Well Name: WARRIOR 2729 FED COM	Well Location: T22S / R28E / SEC 26 / NWSW / 32.3613846 / -104.0657159	County or Parish/State: EDDY / NM
Well Number: 204H	Type of Well: OIL WELL	Allottee or Tribe Name:
Lease Number: NMNM19842A	Unit or CA Name:	Unit or CA Number:
US Well Number: 3001557657	Operator: MATADOR PRODUCTION COMPANY

Notice of Intent

Type of Action: APD Change

Sundry Request

Casing Specs - 7-5/8" 29.7lb MO-FXL

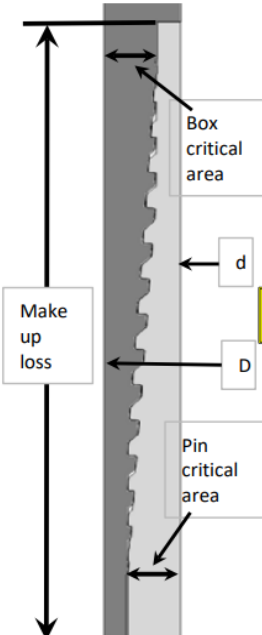
- Option to drill intermediate hole size of 8.75" OH
- Option to run intermediate casing type of 7-5/8" MO-FXL
- Cement volumes will be adjusted accordingly to reflect change of intermediate hole size

Note: This confirms that the operator is approved to drill an 8-3/4" hole for the intermediate section and run 7-5/8" casing with MO-FXL flush joints. Adjust cement accordingly.
